North Campus Faculty Housing Phase II  
Project No. FM110407L/986315

**Addendum No. 6**

ADDENDUM NUMBER 6  
to the  
CONSTRUCTION DOCUMENTS

**BUILDING 700A: SECTIONS**

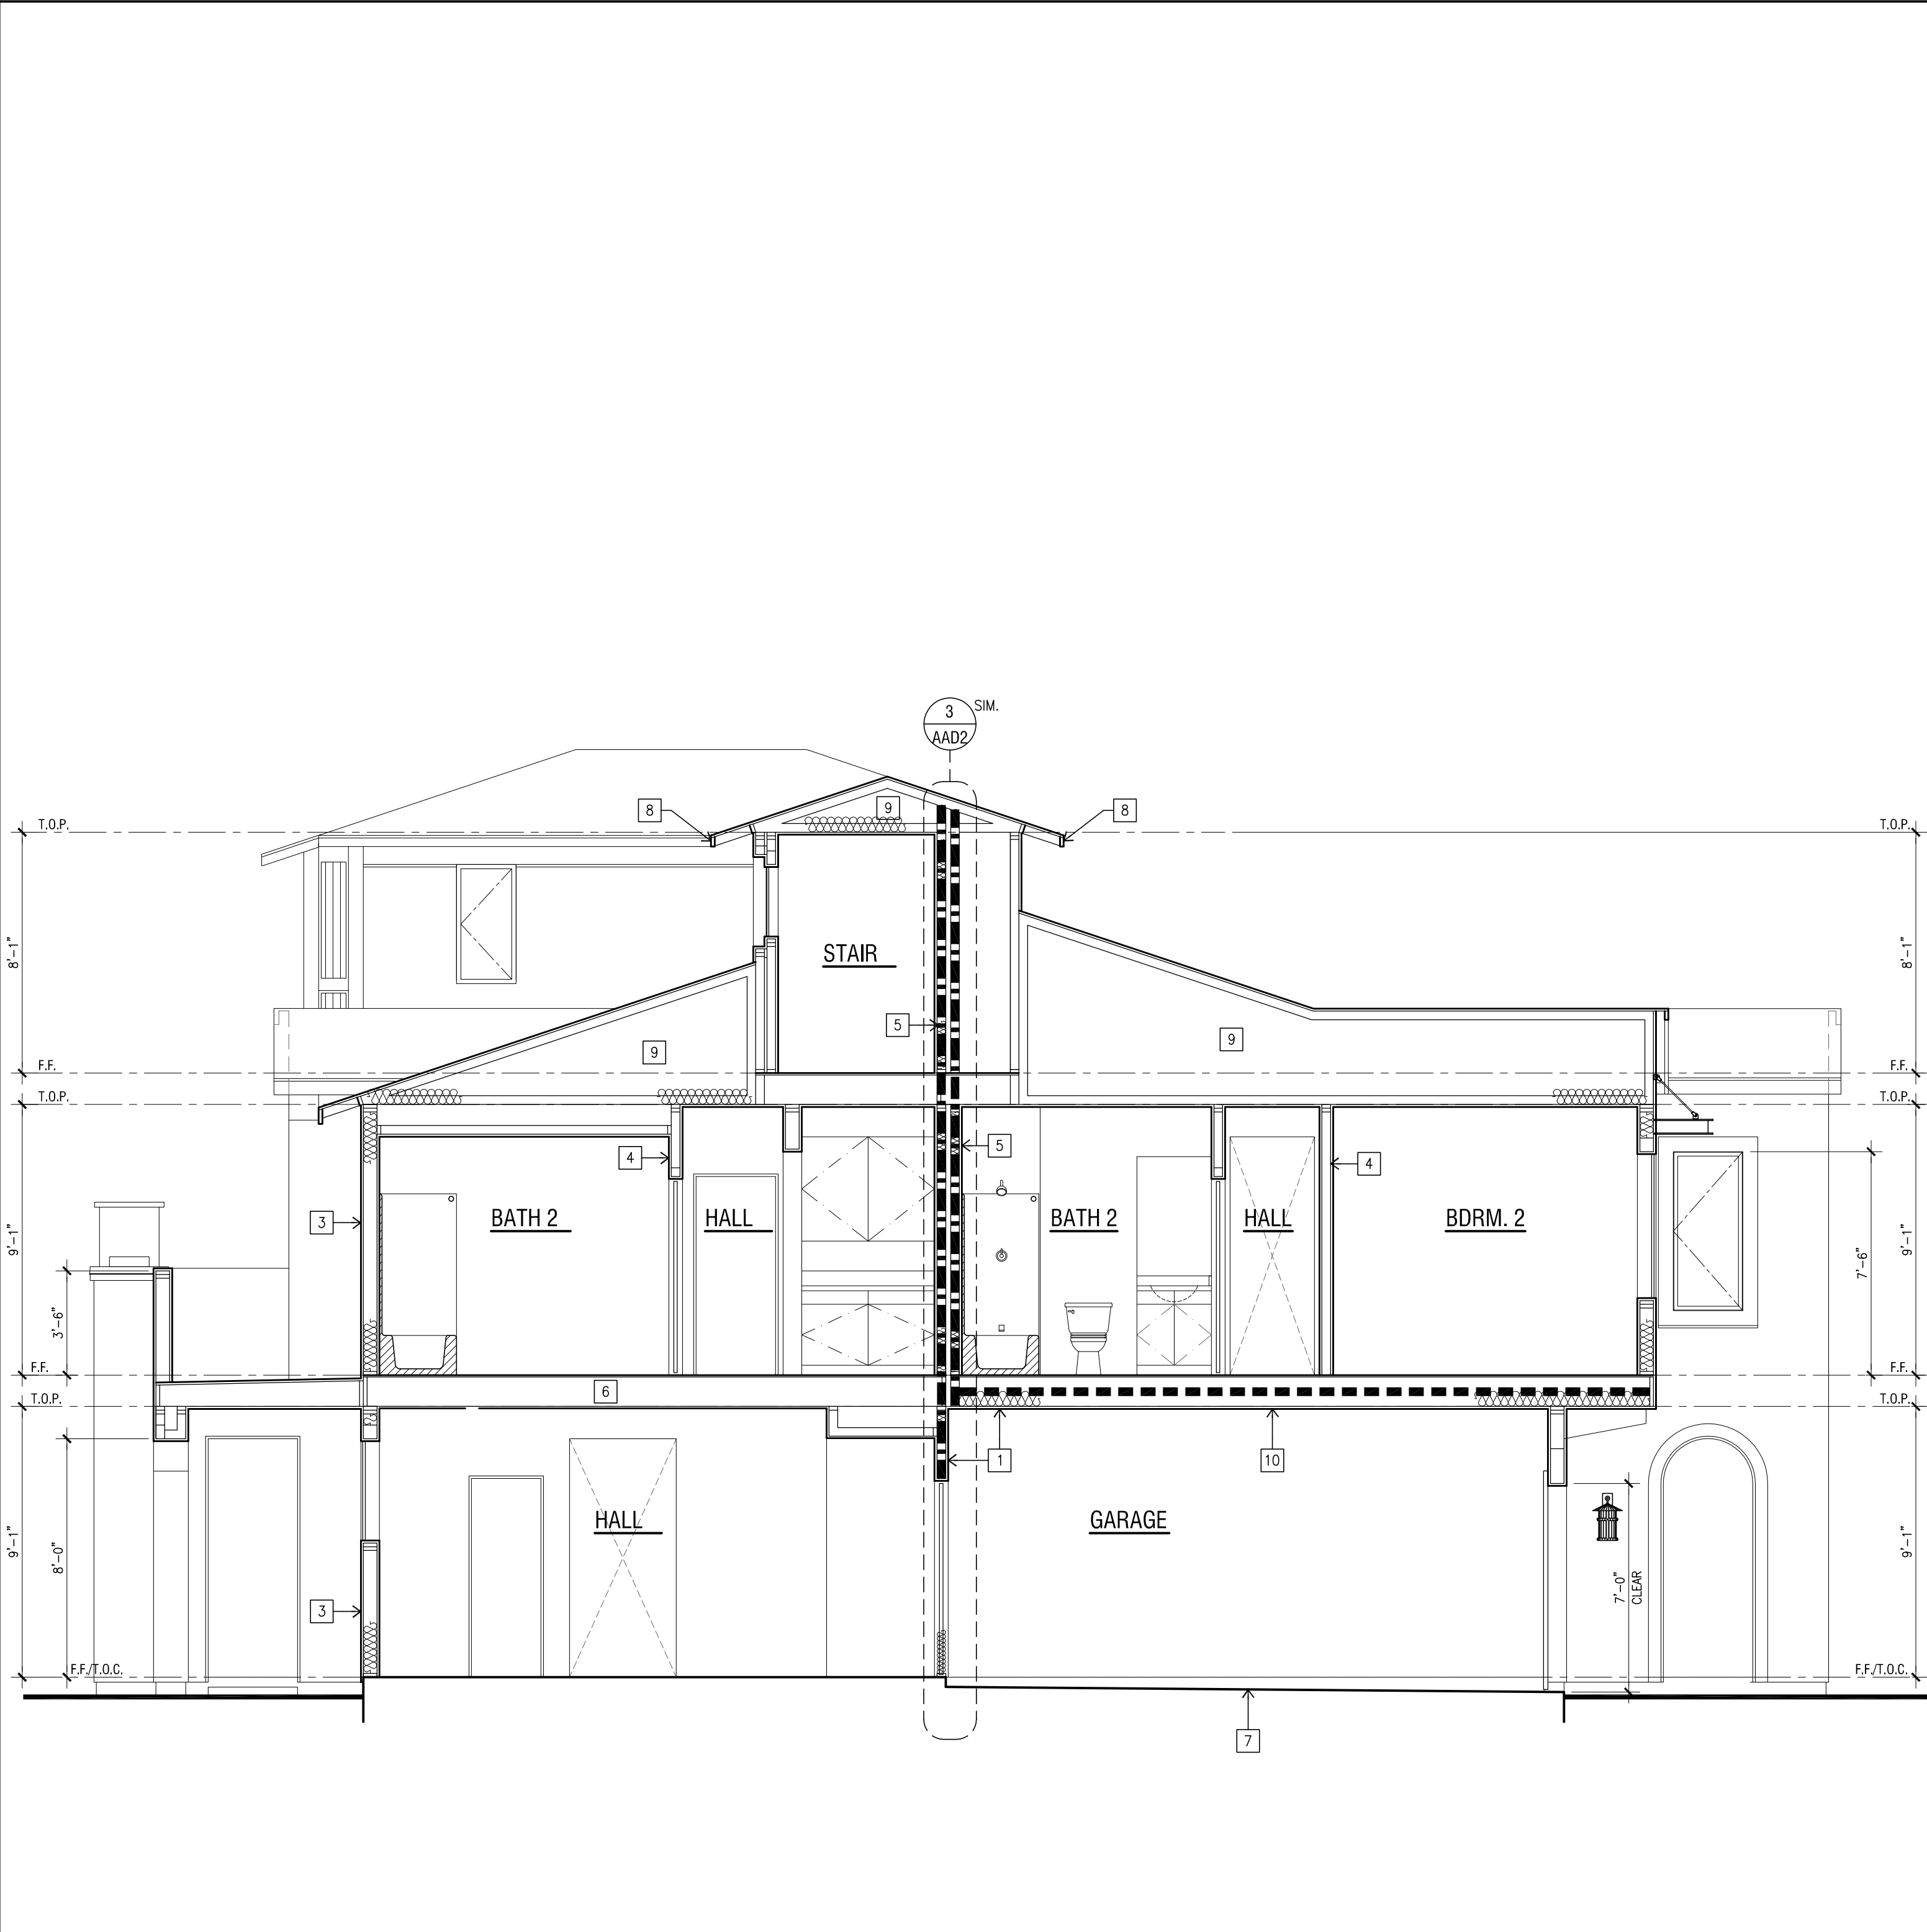
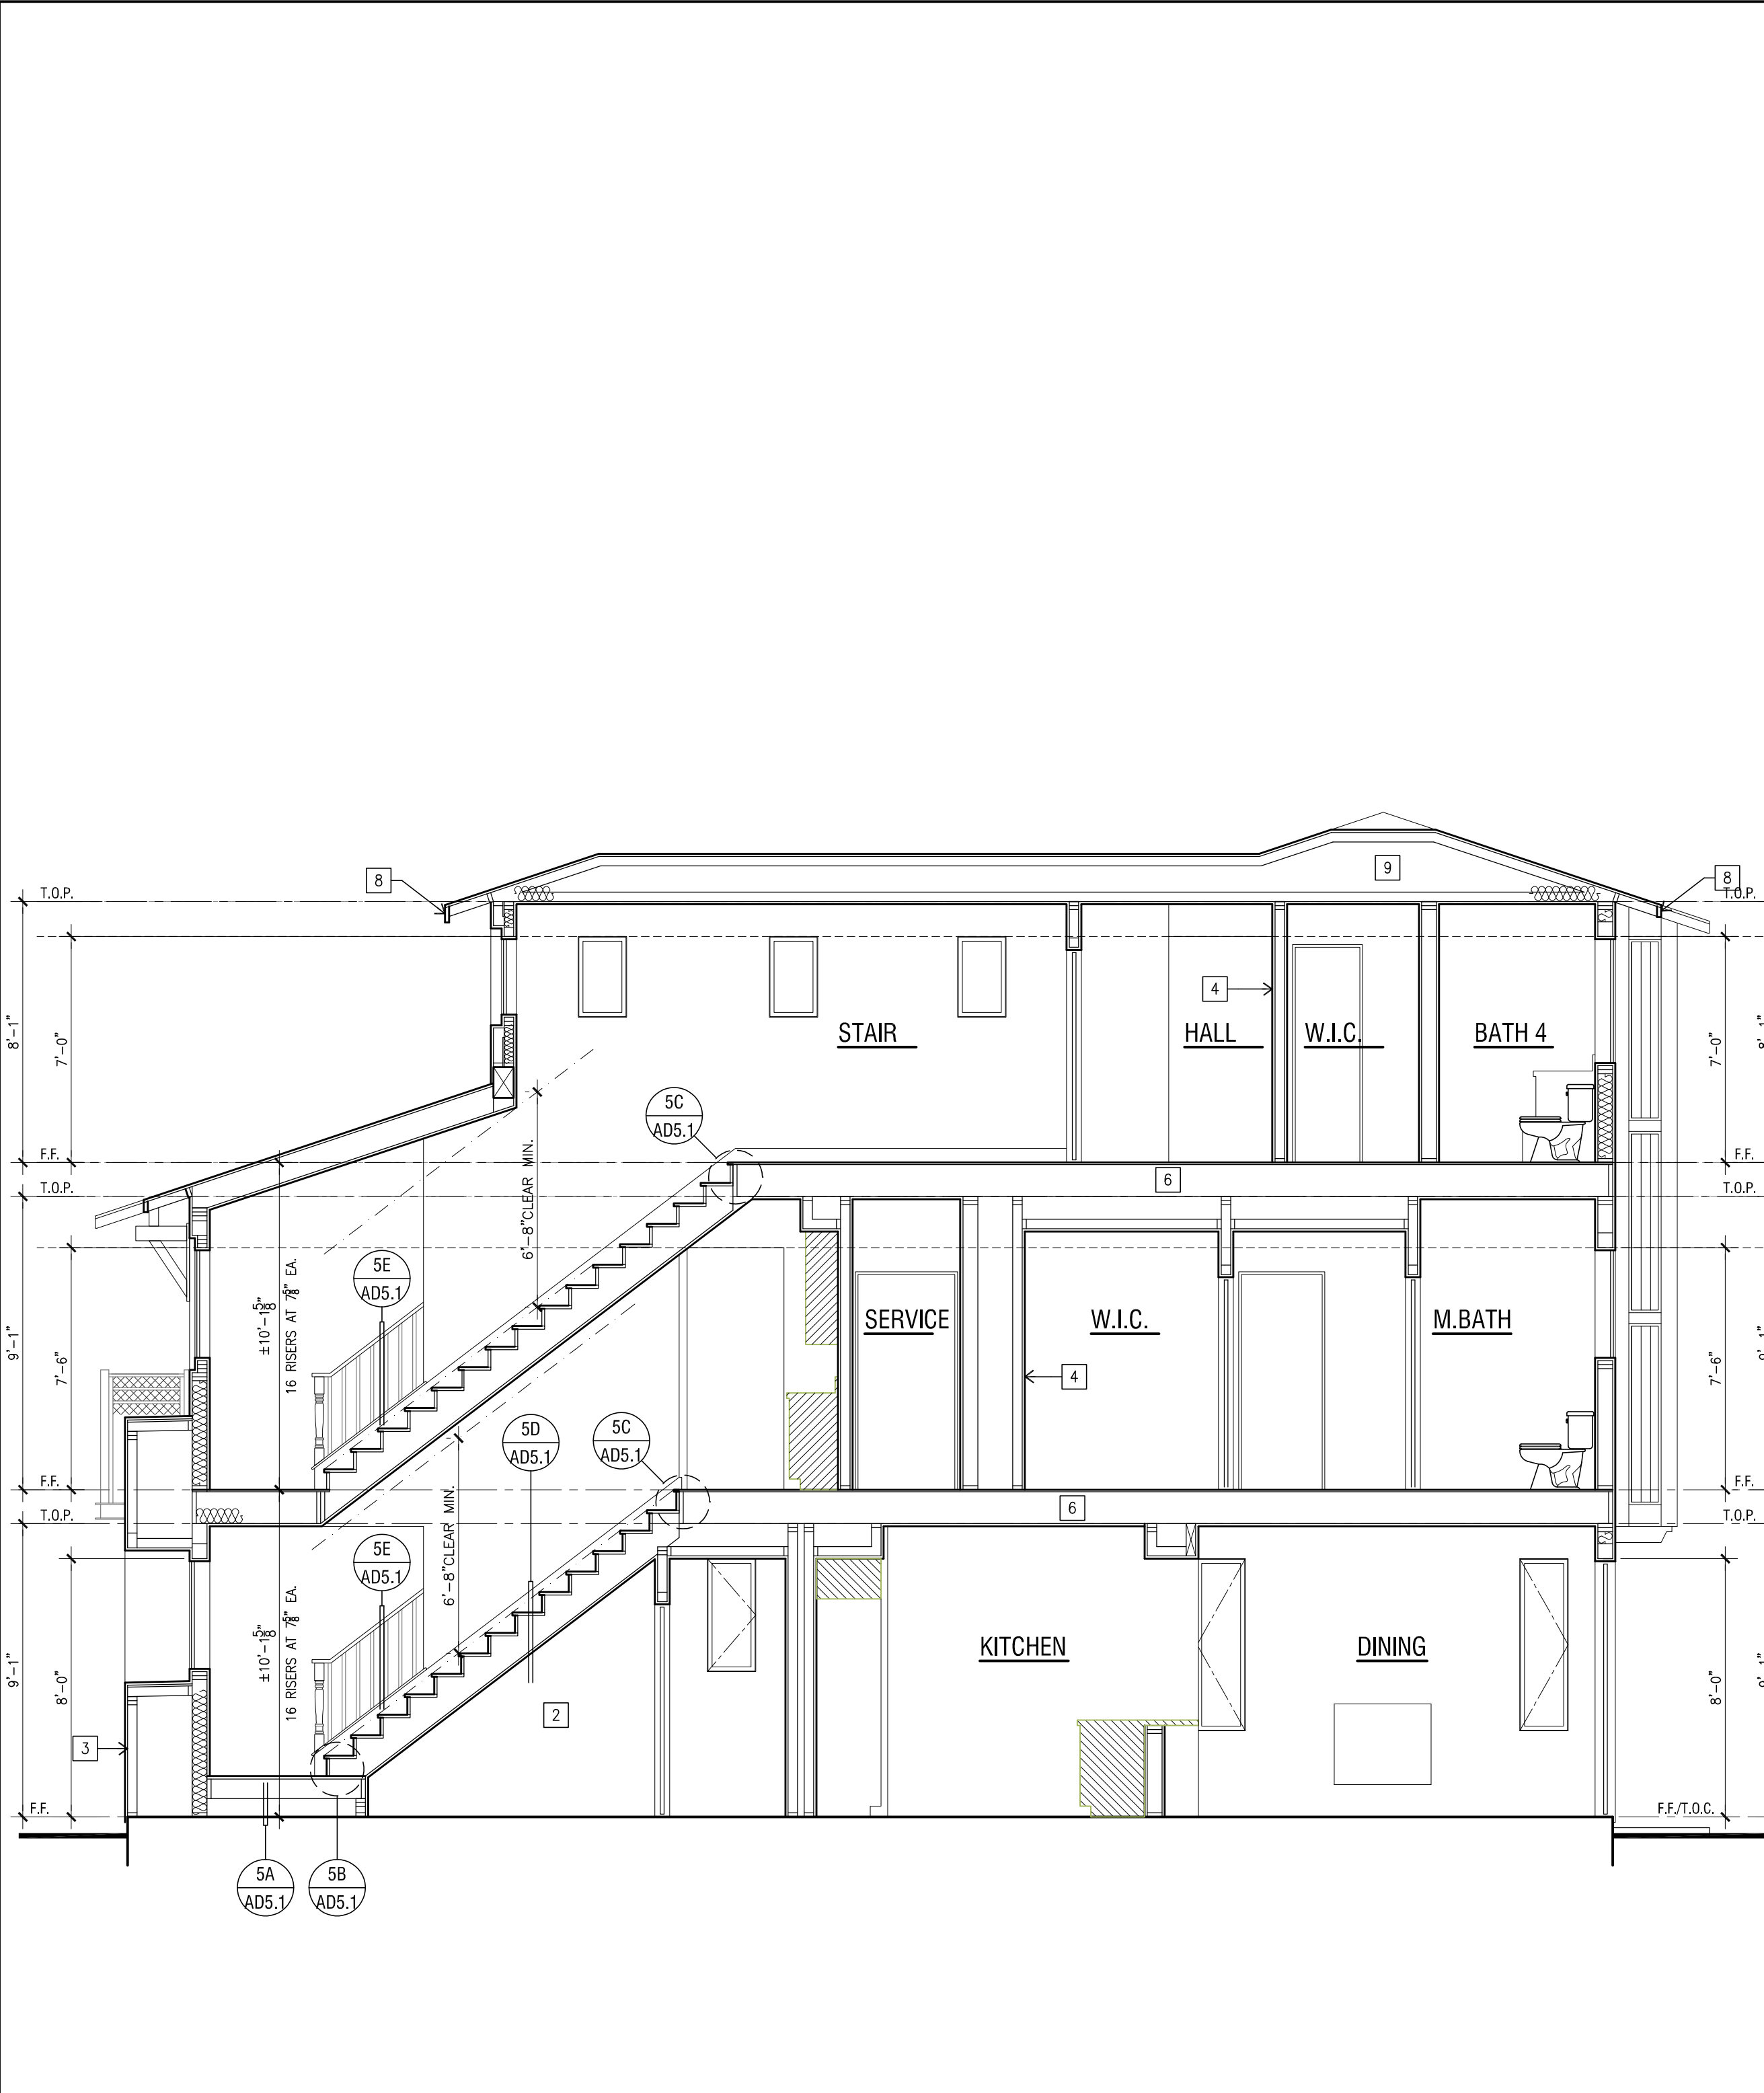
Sketch 5 of 8	Building 600A: Reverse: Sections
Sketch 6 of 8	Building 600B: Sections
Sketch 7 of 8	Building 700A: Sections
Sketch 8 of 8	Building 700A: Reverse: Sections
